ADDENDUM NO. 1

WASHINGTON STATE PARKS AND RECREATION COMMISSION WILLAPA HILLS STATE PARK TRAIL MENLO TRAILHEAD SW-C1219

DATE: May 29, 2025

LAYOUT PLAN

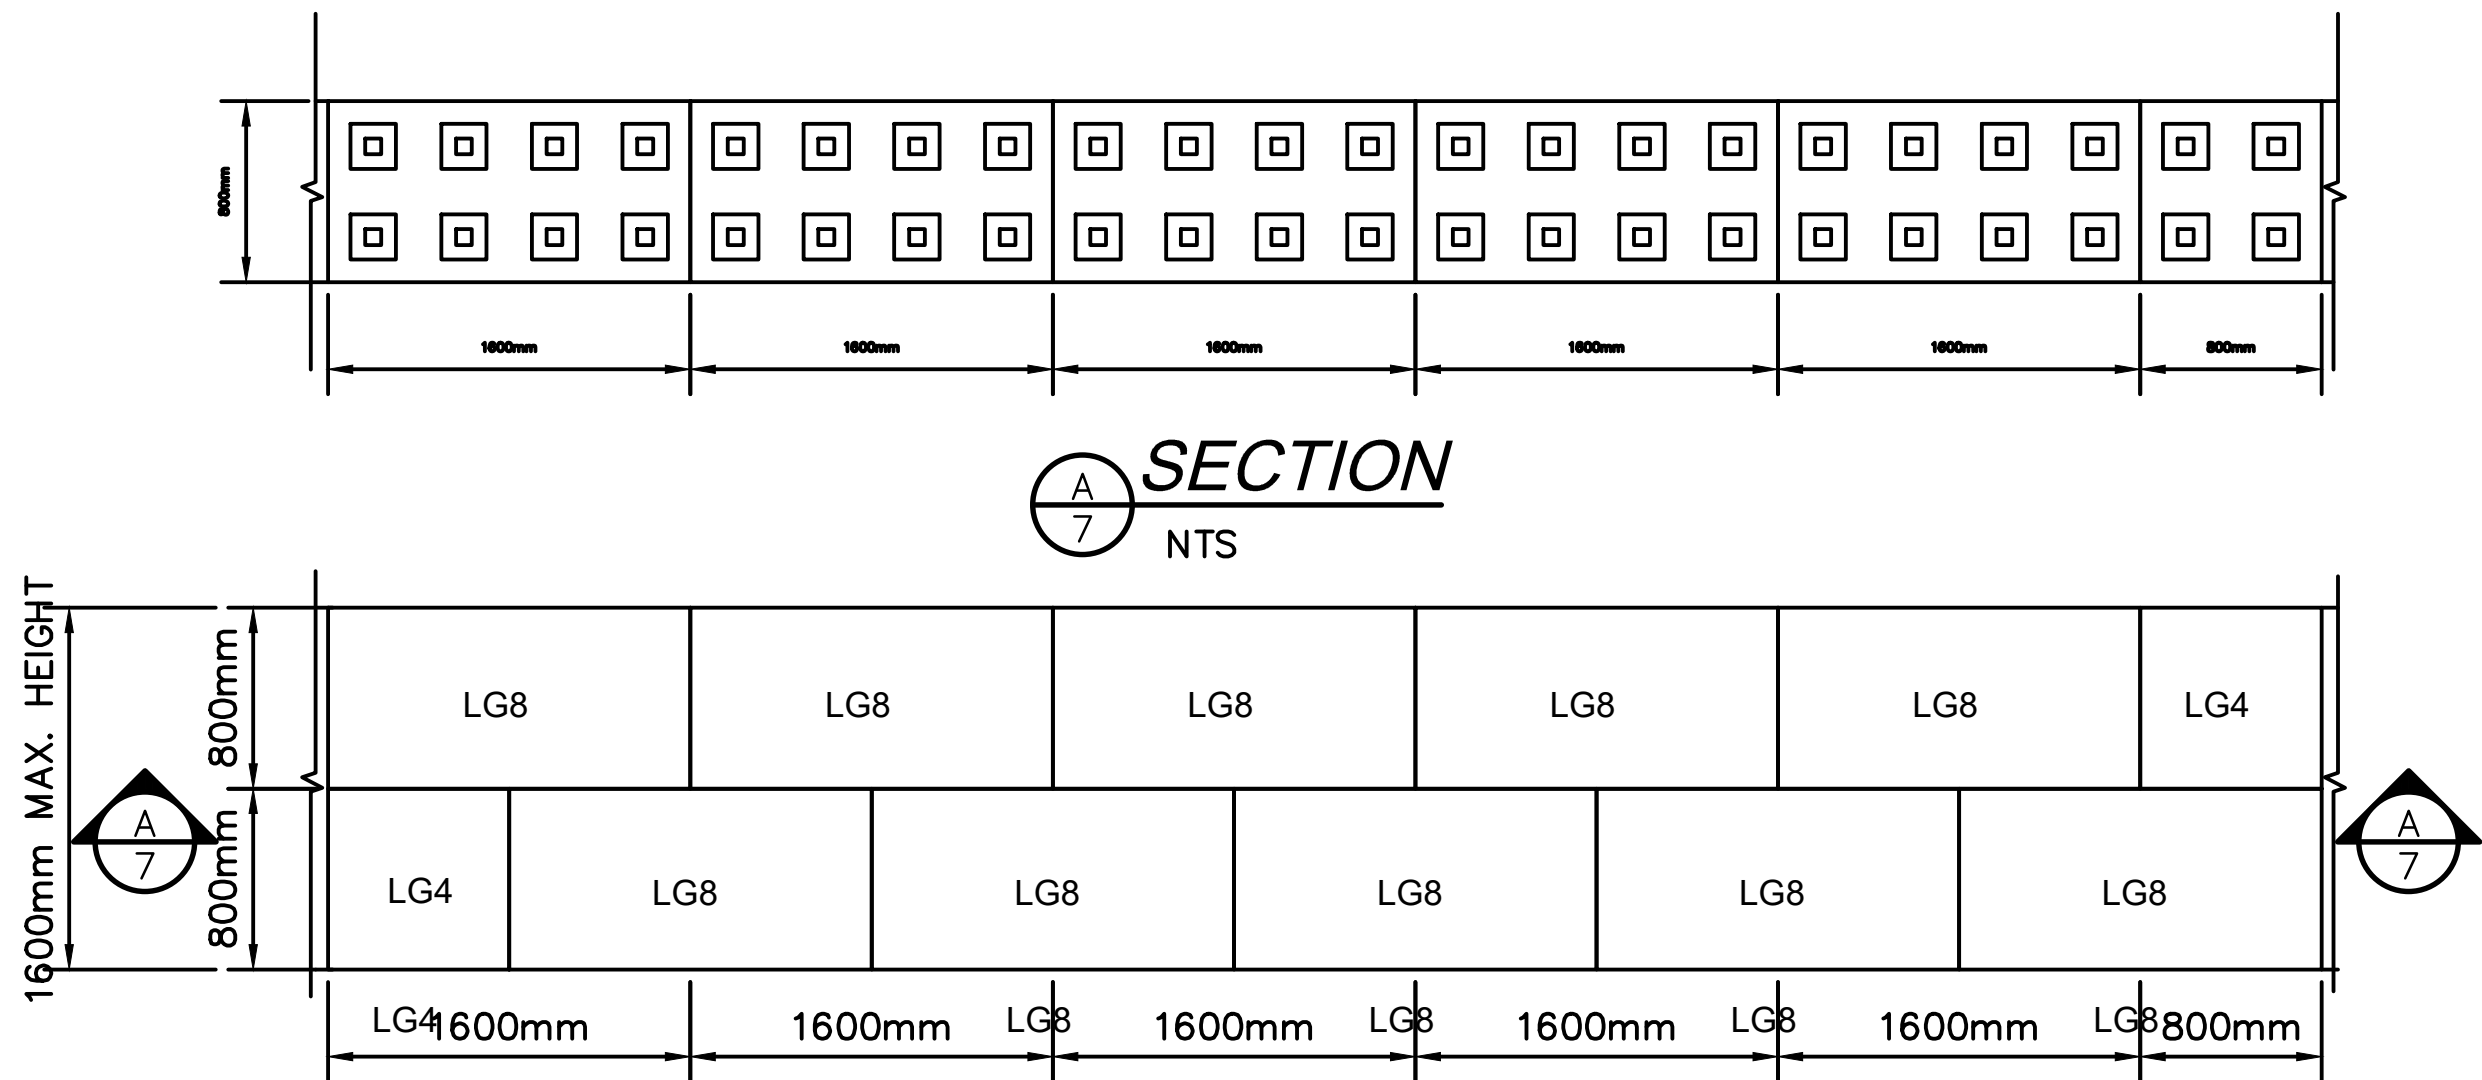
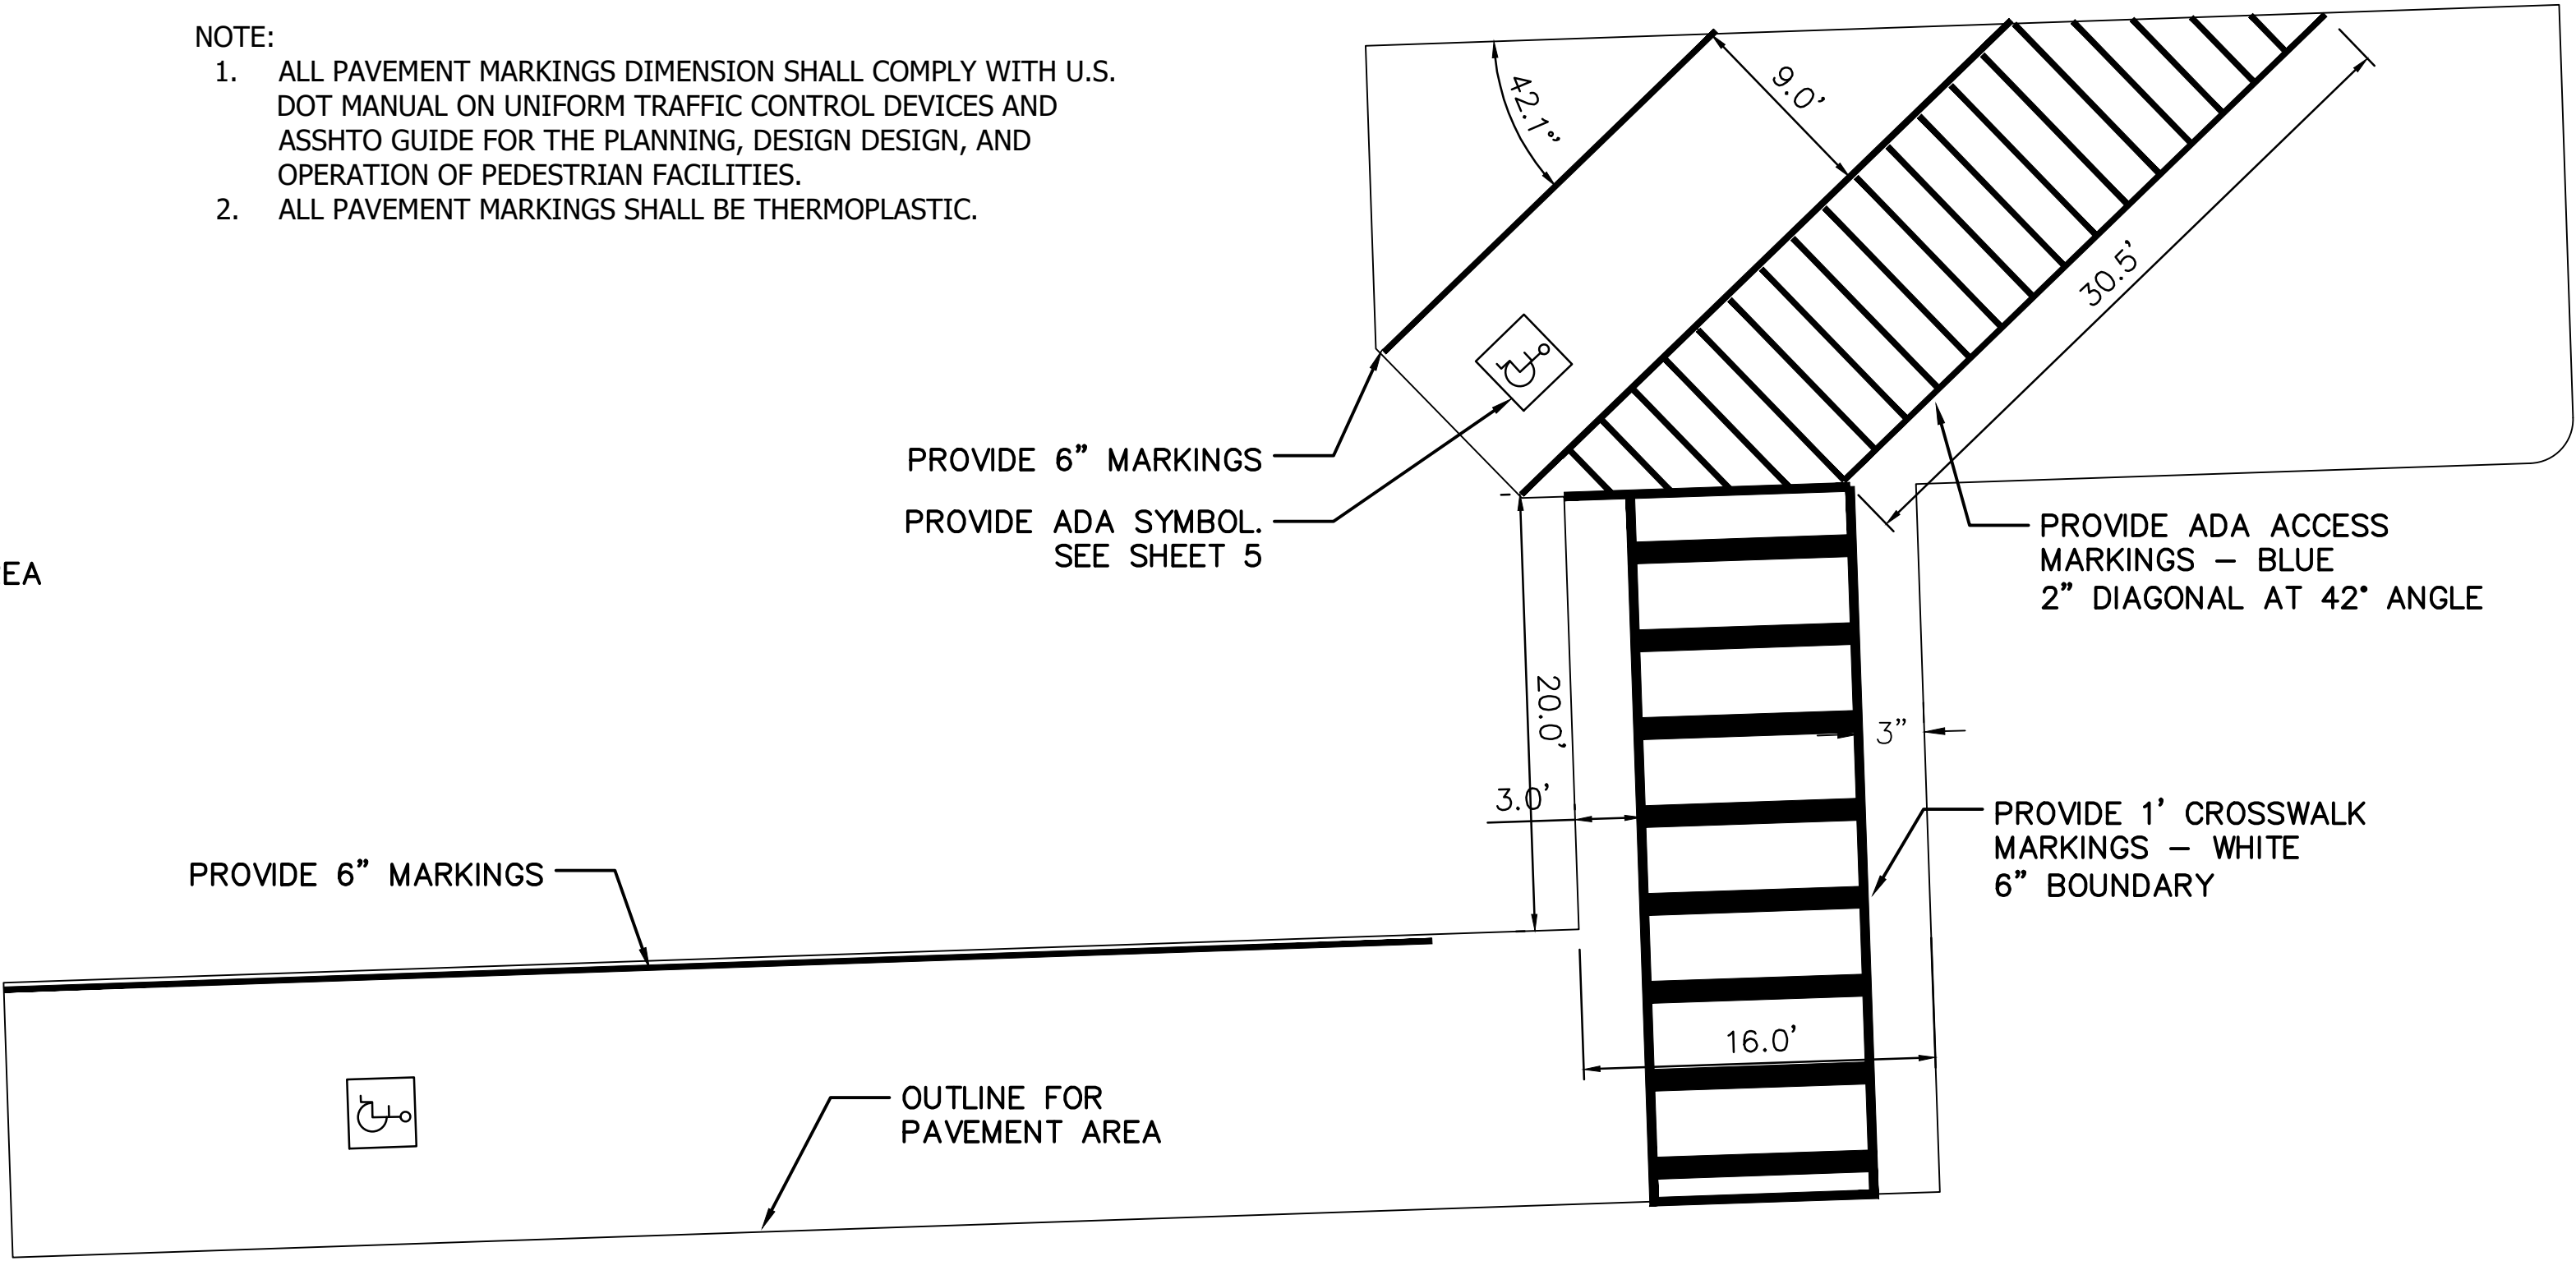
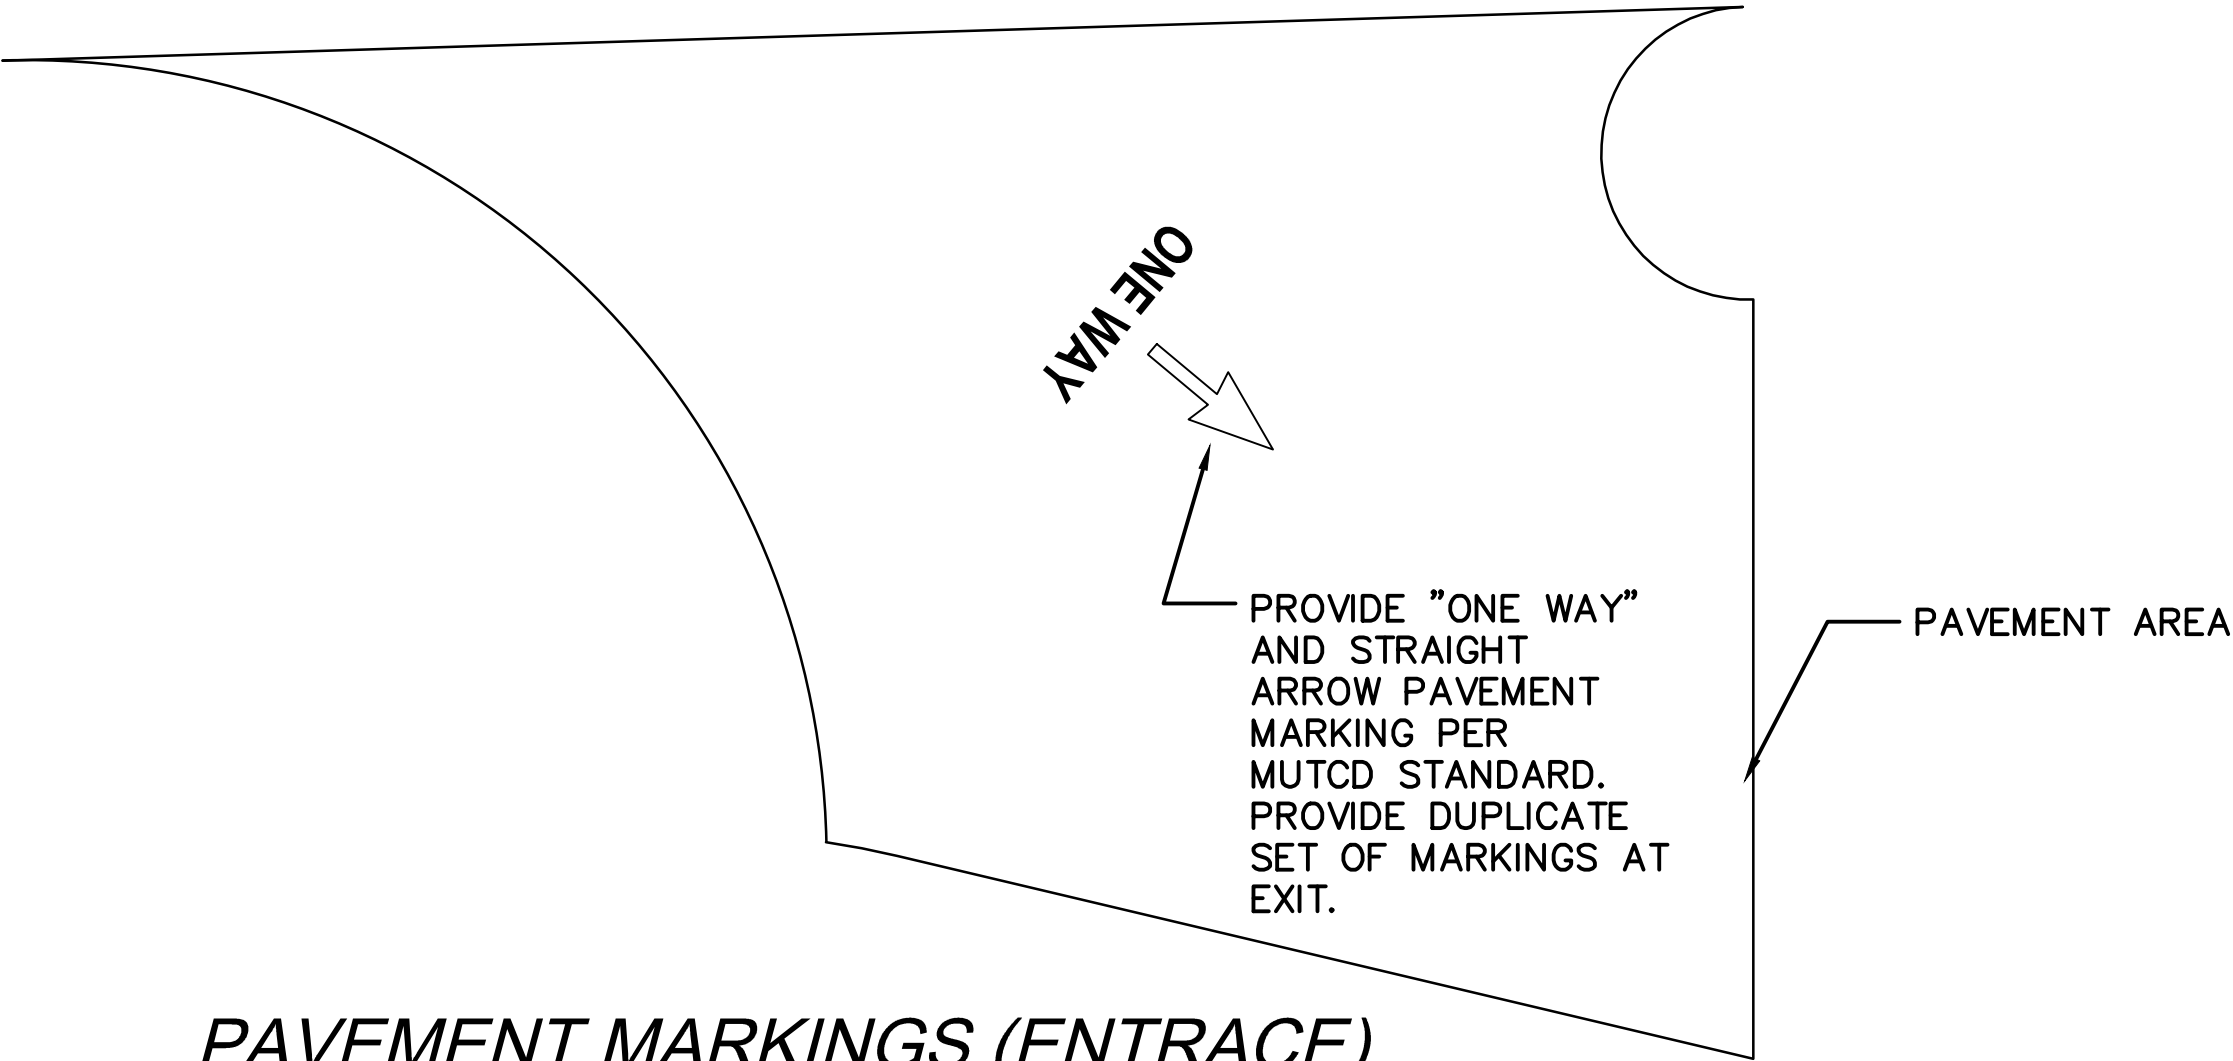
- Sheet 3** **Revise:** Call outs for Kiosk – Install Park Furnished Kiosk See Sheet 10
Call out for Retaining Wall - Provide retaining wall see sheet 4 & 7
- Sheet 7** **Revise:** Retaining Wall Notes – 3. Add or approved equal.
- Sheet 8** **Delete – Not in Contract**
- Sheet 9** **Delete – Not in Contract**
- Sheet 10** **Revise – Only Post Base Detail Included in Contract**
- Sheet 11** **Delete – Not in Contract**
- Sheet 12** **Revise:** Note call out Project Begins Limits & Project Ends Limits
Drawing Legend Notes - Bollard – Install Park Furnished bollards as directed (TYP 44)
22
